Addendum 108 – UN Regulation No. 109

Revision 1 - Amendment 5

Supplement 11 to the original version of the Regulation – Date of entry into force:
3 January 2023

Uniform provisions concerning the approval for the production of retreaded pneumatic tyres for commercial vehicles and their trailers

Figure, amend to read:

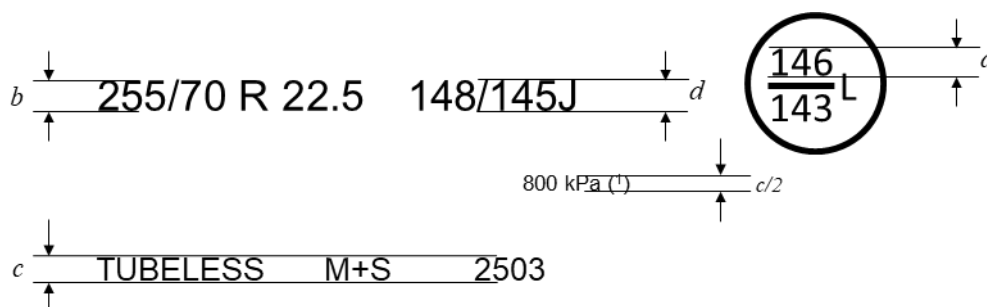
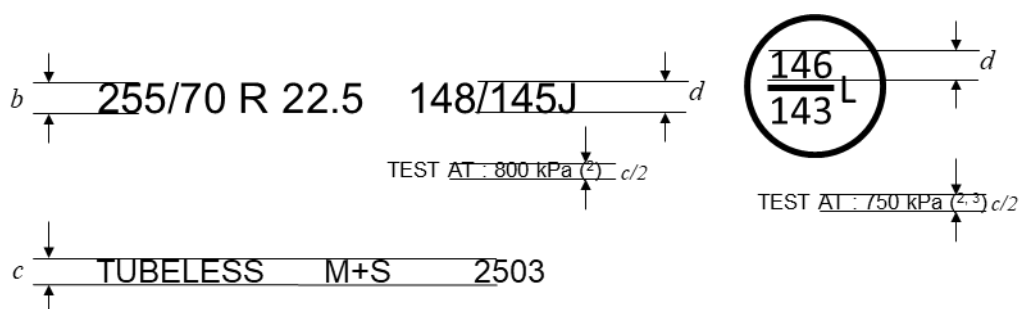
Annex 3,

"Example 1:

- (1) PSI marking instead of kPa is allowed for tyres first type approved before 1 January 2018. The kPa marking may be preceded by "TEST AT : " or, alternatively, by "TEST INFL : " or the symbol "@".

Example 2:

- (2) "TEST AT : " may be replaced by "TEST INFL : " or the symbol "@" or be omitted.
(3) The indication of a second inflation pressure for the additional service description is optional. If there is no indication, the same test inflation applies to both load/speed combinations.

Dimensional requirements for further markings (4):

- (4) For "ML" and "MPT" being part of the tyre size designation marking the minimum dimension *b* applies."
